PUBLIC HEARING MEMORANDUM

SUBJECT: **Petition #338-18(2)**, for a SPECIAL PERMIT/SITE PLAN APPROVAL to amend Special Permit Council Order #338-18 to allow modifications to the site plan for driveway and patio spaces not shown on the approved site plan at 22 Beecher Place, Ward 6, Newton Centre, on land known as Section 81 Block 01 Lot 03 containing approximately 10,146 sq. ft. of land in a district zoned MULTI RESIDENCE 1. Ref: Sec. 7.3.3, 7.4 of the City of Newton Rev Zoning Ord, 2017.

MEMORANDUM

Re: Special Permit – 22 Beecher Place

Special Permit-approved site plan:

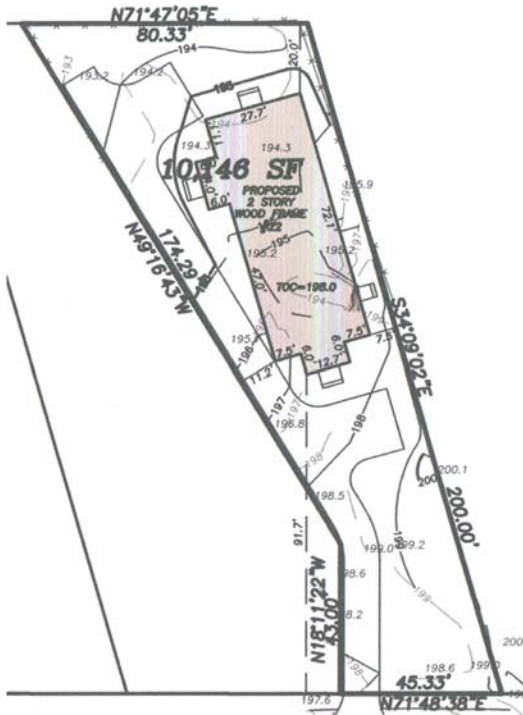
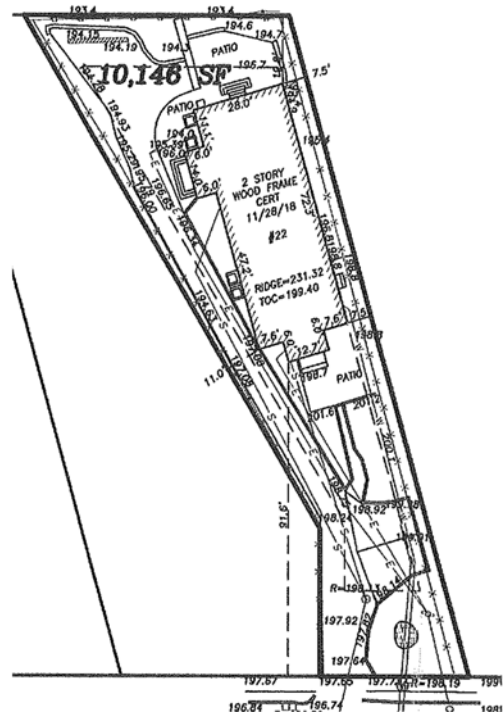
As built, the front parking area is located closer to the front lot line with, and its approved location is now generally occupied by a patio which was not shown on the approved plans and extends to the front façade of the dwelling and extends partially down the right side of the property between the dwelling the right property line. A paved walkway connects this parking area and the patio.

The other parking area, in the rear left of the property, has been built beyond that which was approved pursuant to the special permit, with the paved surface extending further to the rear property line. A second unapproved paved patio has been constructed in the rear right of the property in an area that was to be left unpaved per the approved plans. This patio has been built surrounded by substantial stone walls and other masonry/stonework, including stone benching and an outdoor fireplace.

As noted by the Engineering Division's memorandum referenced below and attached, these changes increase the impervious surface. The Planning Department further notes that these changes alter the project's visual character as seen from adjacent public way and abutting properties and recommends the petitioner explore ways to reduce the paving on site
